CUSTOMER REQUIREMENT CHECK LIST

COMPANY NAME : PT. KOSTEC INDONESIA
 PIC : SITI NURHASYANAH
 PHONE/FAX NO. : 021-89833182/84
 E-MAIL : nurhasyanah@yahoo.com

QUALITY CONFIRMATION

STANDARD PACKAGING

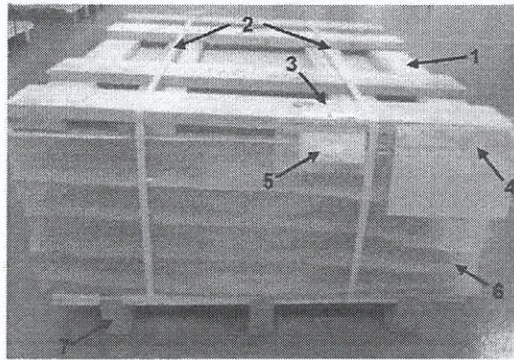
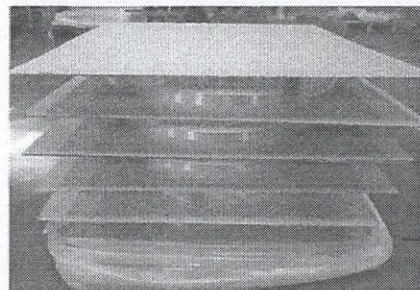
1. LABEL COIL
2. SILICA GEL
3. LAYER/KARTON
4. COIL DI IKAT PLASTIK WRAPPING

1. PALLET ATAS
2. TALI STRAPPING
3. PALLET NO.
4. PACKING CARD
5. SAMPLE MATERIAL
6. PLASTIK BAG
7. PALLET BAWAH

500mm (Tinggi Max. Susunan Coil Material)

Standard Packaging = ☒ OK ☐ NG Tanggal 12.08.2020
